ADDENDUM NO. 3

Reference: New Classroom Building
UVU - Orem, Utah
DFCM Project No. 12192790

ADDENDUM NO. 3
May 22nd, 2013

Utah Valley University Classroom Building
Orem, Utah

North Elevation (D5 / AE202)
1/16" = 1'-0"

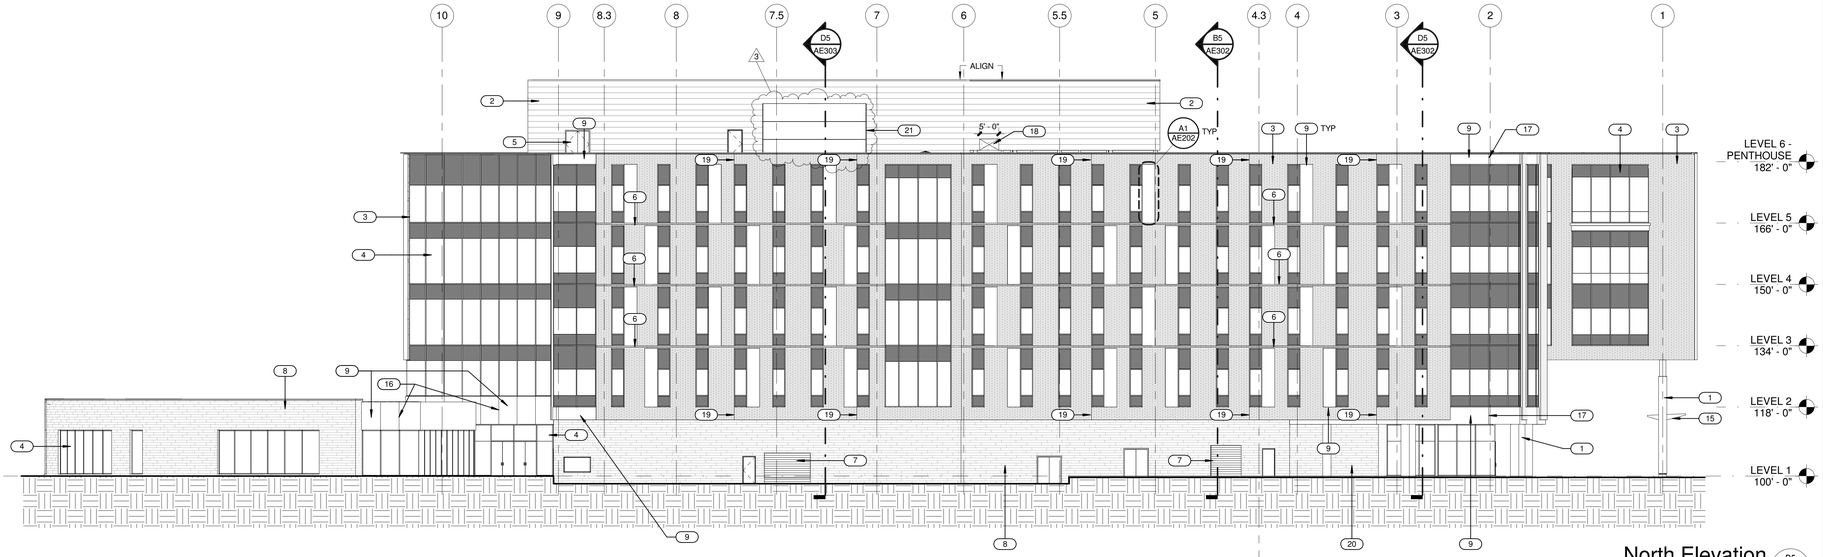
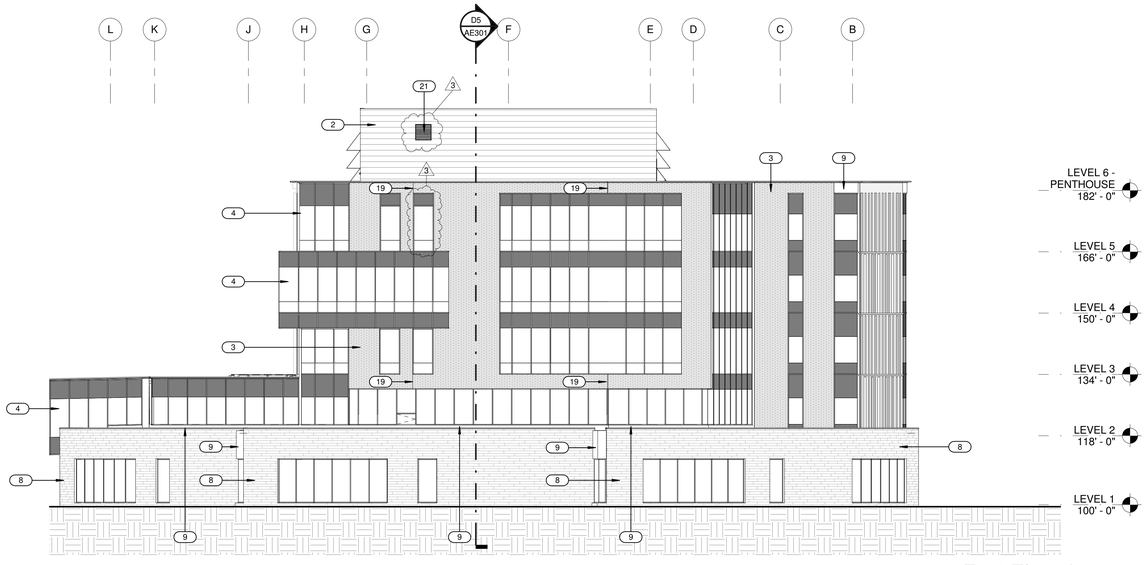
8. Sheet D5/AE202, size of louver modified to match mechanical louver size as scheduled. Added louver to match mechanical scheduled louver to B4/AE202.

Enlarged Plan Detail (B4 / AE511)
1 1/2" = 1'-0"

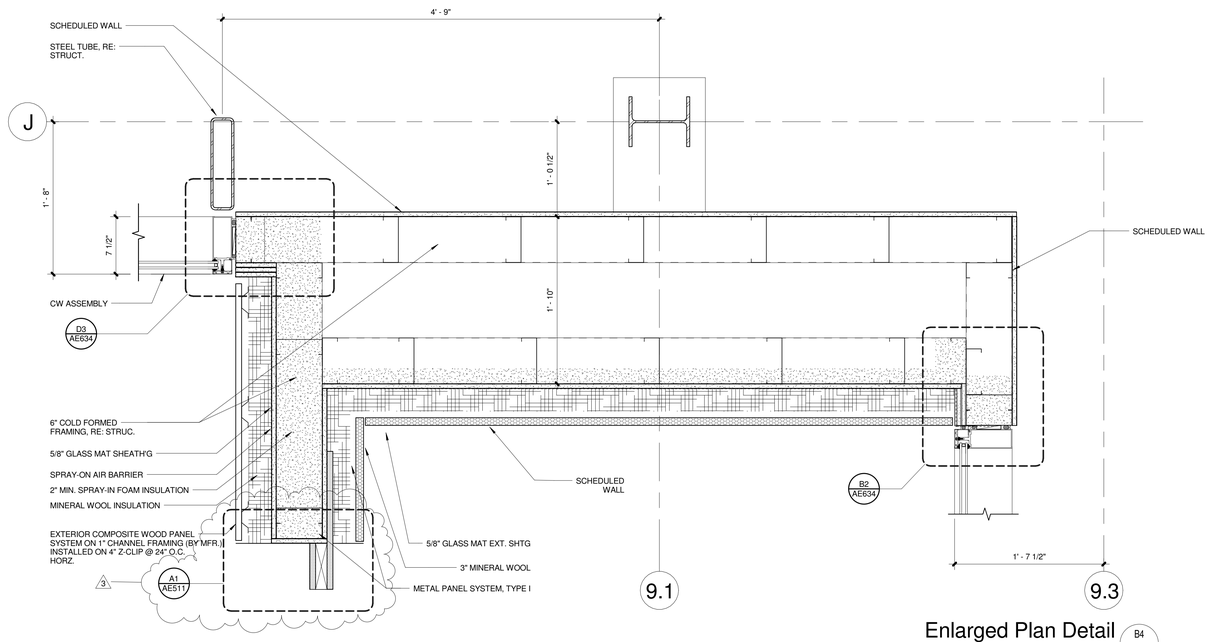
9. Sheet AE511, revised note on detail C3 & B4/AE511 to read "EXTERIOR COMPOSITE WOOD PANEL SYSTEM".
10. Sheet AE111A, revised floor finish of Toilet Rooms 100L, 100M, 100N. Revised wall finish at concrete wall at grid line intersection J & 5. Added base to wall & base specific tag for wall and base finish.

LEVEL 2 MECHANICAL FLOOR PLAN - ALTERNATE

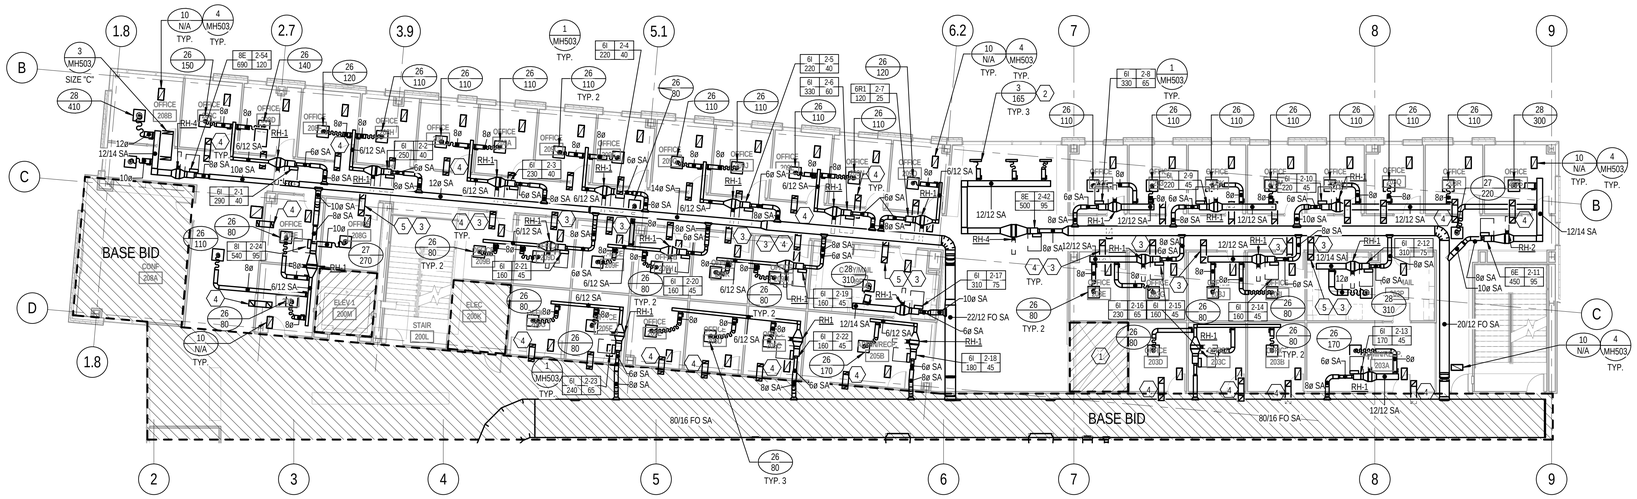
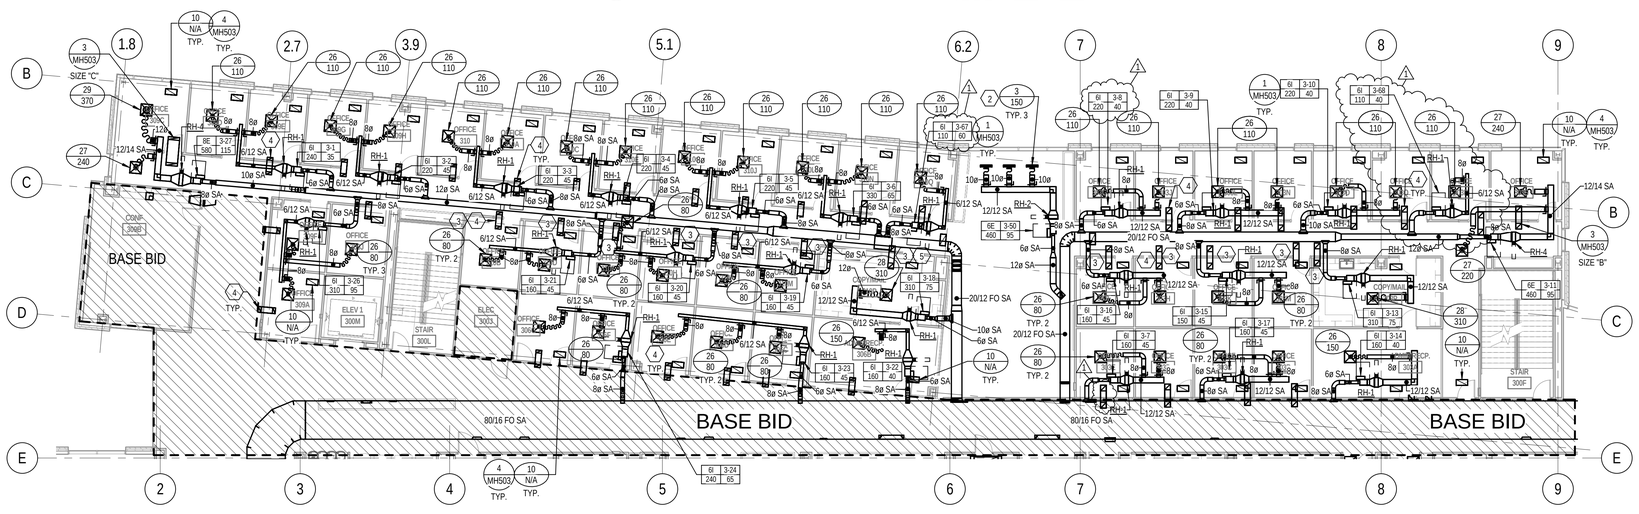
Item No.	Add, Delete or Clarify	Specification Section or Drawing No.	Reference / Description:
3.6	Clarify/Add	MH102.1 MP102.1	-There were two VAV boxes tagged as 3-7, changed one to 3-67. -Added VAV box 3-68. -Added transfer air in office 303E. -Adjusted the CFM at VAV box 3-8. -Now showing VAV box 4-56 as part of the alternate as well as base bid.

1 LEVEL 1 AREA 'B' PLUMBING FLOOR PLAN

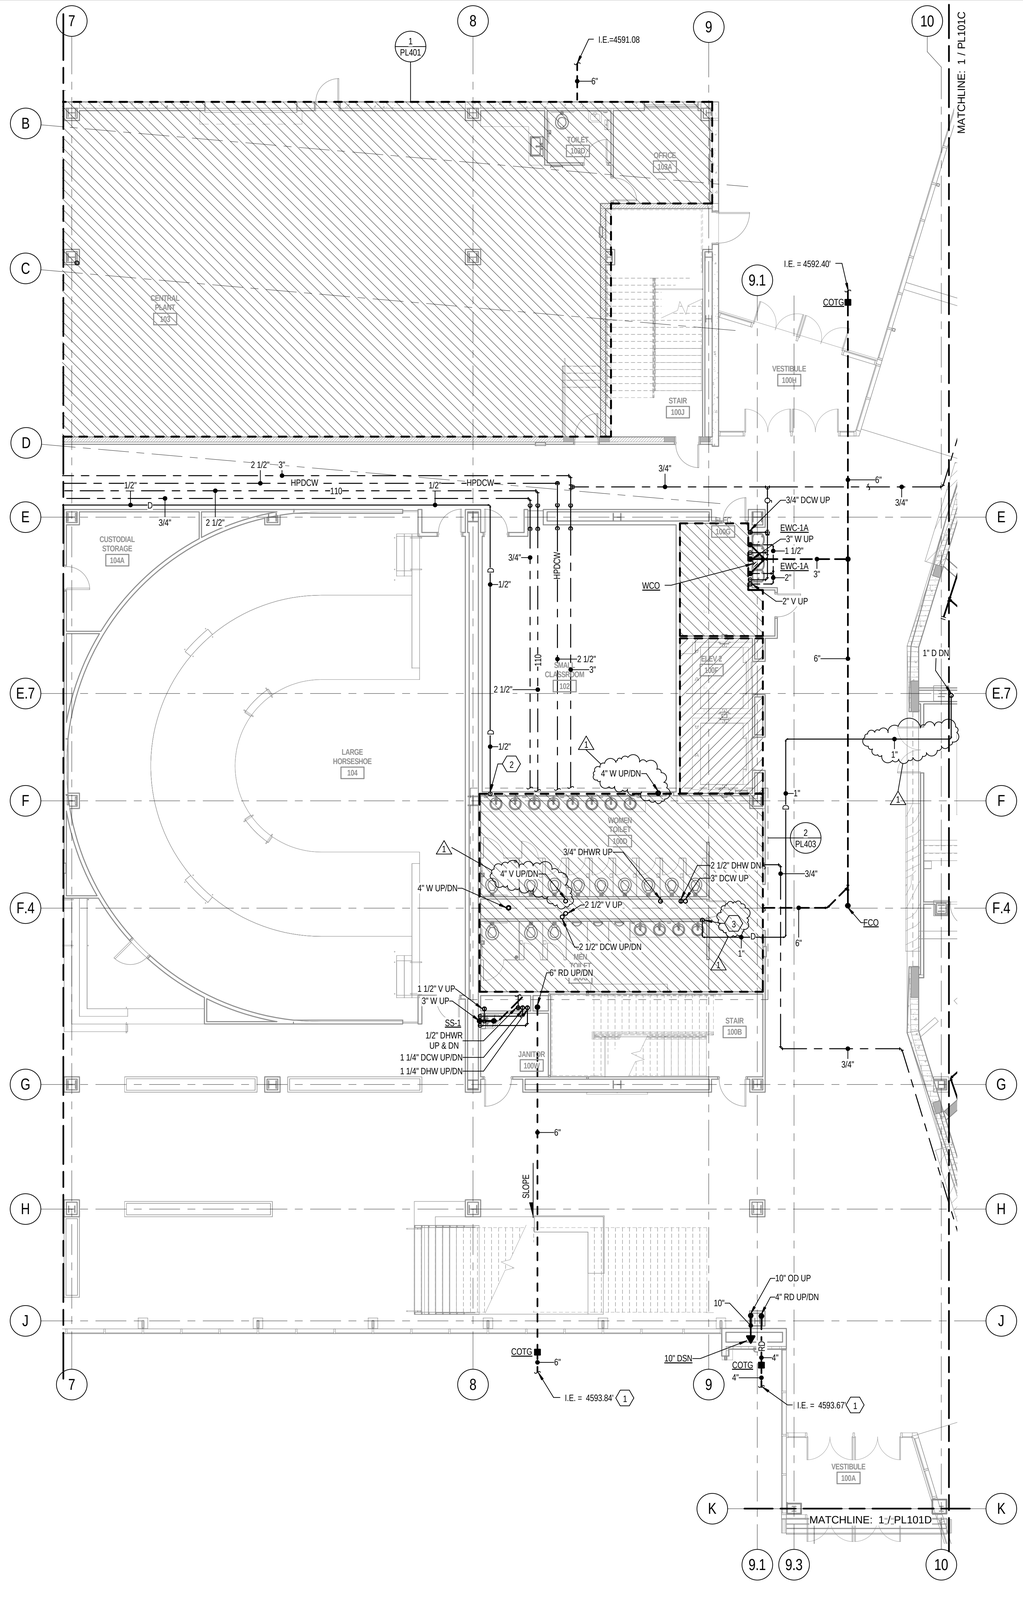
3.14	Clarify	PL101B	-Added keyed note #3. -Clarified pipe sizes.
3.15	Clarify	PL101C	-Clarified pipe size.
3.16	Add	PL102.1	-Added General Notes
3.17	Clarify	PL102A PL103A PL104A PL105A PL405 PL401	-Clarified pipe sizes.
